RUSSIAN MARITIME REGISTER OF SHIPPING

CIRCULAR LETTER

No. 312-09-1719c

amendments to the Rules for the Classification and Construction of Sea-Going Ships, 2022, ND No. 2-020101-152-E

Fig. 1.1.1-1
Maximum extent of Arctic waters application¹

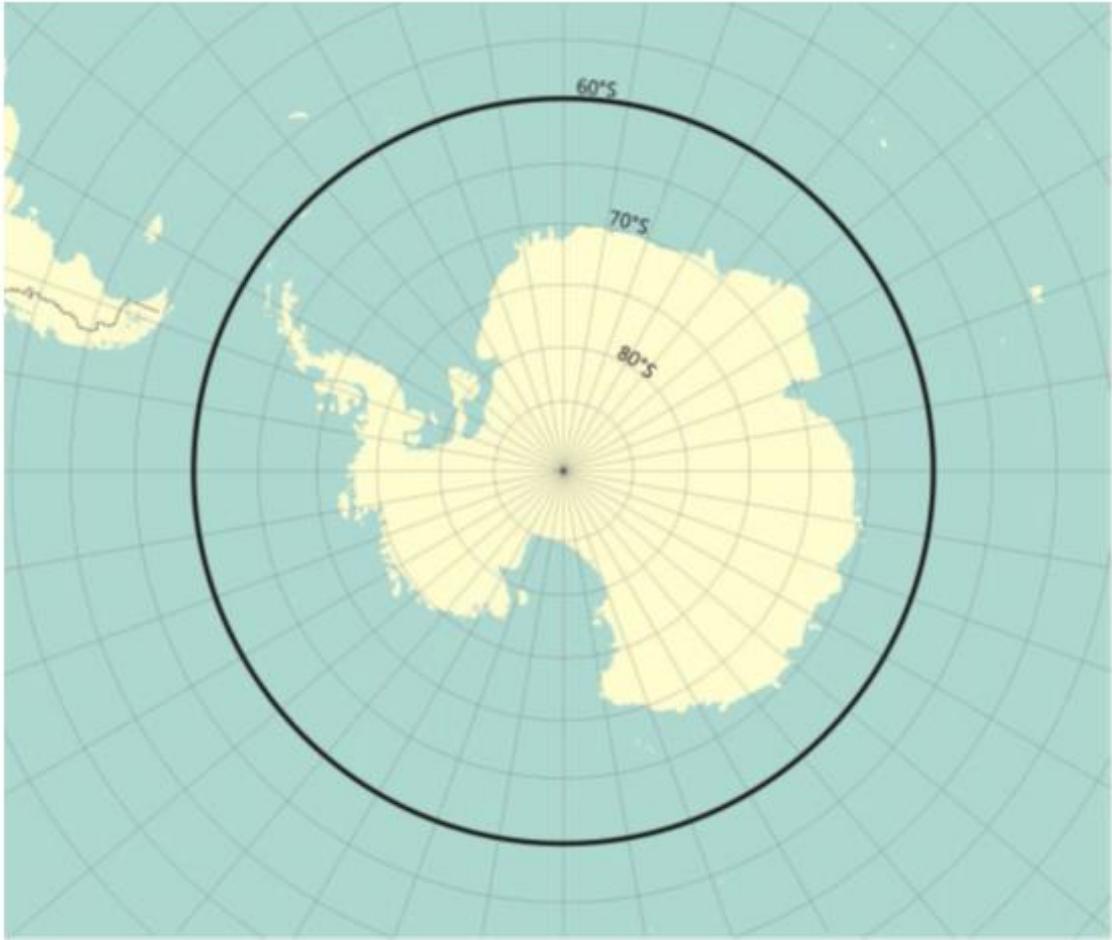
1 **Para 1.1.1.** Before the definition "Crew boat" new definition "Polar waters" is introduced:

"Polar waters — includes both Arctic waters and the Antarctic area.

.1 Arctic waters are those waters which are located north of a line from the latitude 58°00',0 N and longitude 042°00',0 W to latitude 64°37',0 N, longitude 035°27',0 W and thence by a rhumb line to latitude 67°03',9 N, longitude 026°33',4 W and thence by a rhumb line to the latitude 70°49',56 N and longitude 008°59',61 W (Sørkapp, Jan Mayen) and by the southern shore of Jan Mayen to 73°31',6 N and 019°01',0 E by the Island of Bjørnøya, and thence by a great circle line to the latitude 68°38',29 N and longitude 043°23',08 E (Cap Kanin Nos) and hence by the northern shore of the Asian Continent eastward to the Bering Strait and thence from the Bering Strait westward to latitude 60° N as far as Il'pyrskiy and following the 60th North parallel eastward as far as and including Etolin Strait and thence by the northern shore of the North American continent as far south as latitude 60° N and thence eastward along parallel of latitude 60° N, to longitude 056°37',1 W and thence to the latitude 58°00',0 N, longitude 042°00',0 W (refer to Fig. 1.1.1-1);
